**RECORD OF SIGNIFICANT FINDINGS and ACTION PLAN.**

**ADDRESS:** Grenfell Tower, Grenfell Road London W11 1TQ

**COMPLETED BY:** Mr C Stokes

**DATED:** 17<sup>th</sup> October 2014

4th FLOOR

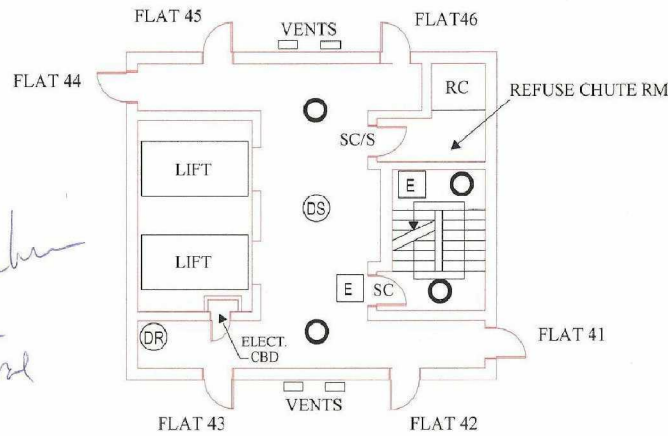
~~Show as~~  
Dows not shut see plan card

~~Reps wall~~  
between 3 & 4  
New bend of duct  
P D

Walking cabinet  
hall in use  
use  
signing walking

Exit sign ↑

~~New entrance Hall~~  
Down the stairs  
Fire Access

# 15th Floor

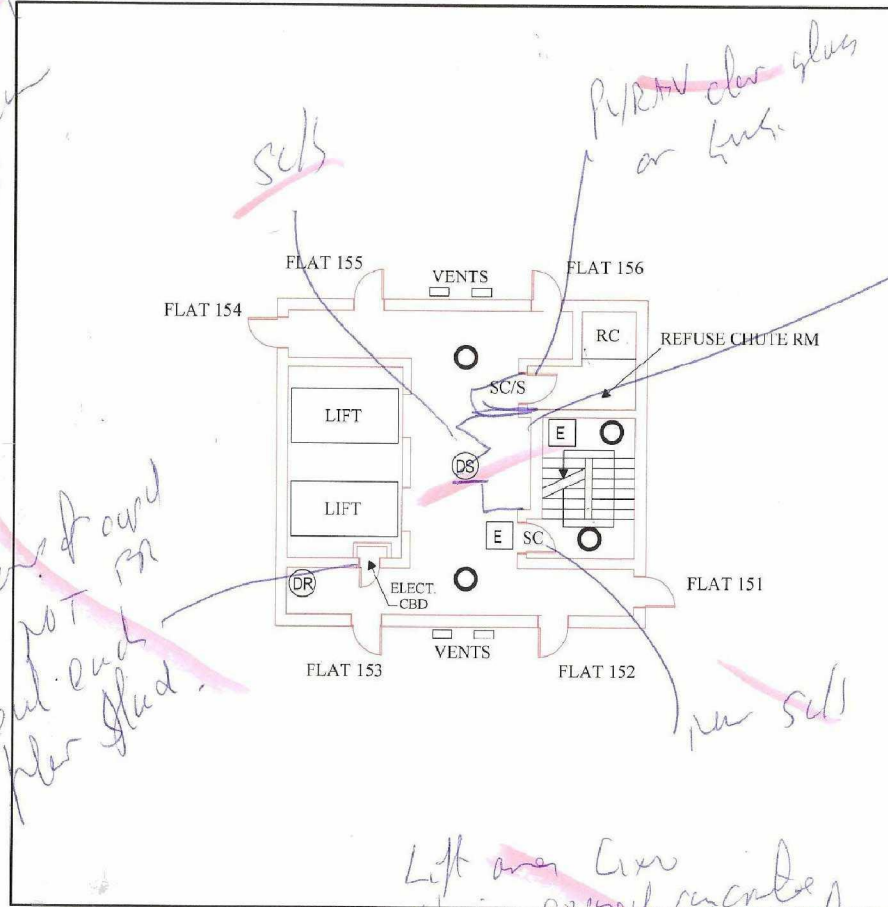
Sign 14 78  
 15th floor  
 fire  
 cord  
 where

~~Part of wall  
 not  
 seal each  
 floor slab.~~

~~see fire spread flow  
 wall  
 5.1.1.1.1  
 floor no wall  
 need to check with  
 new floor  
 provide lift floor no +  
 flat no~~

~~Lift over fire  
 stair open  
 wall not sealed  
 New fire ceiling install  
 pipe work~~

### Roof Level

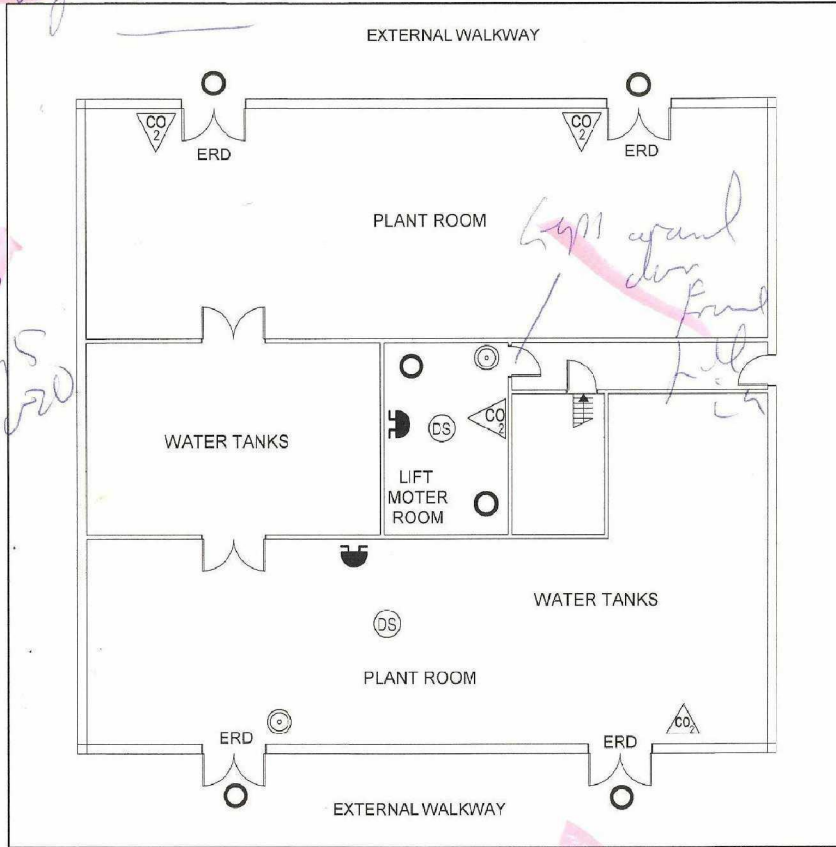
PR ally in Box

dechy  
stands  
11-6-2015  
6-2020

16-3-16  
Lifts

out 14 lift  
CHASO

Water tanks  
relief tanks  
at this level

Hold  
meat  
fill in
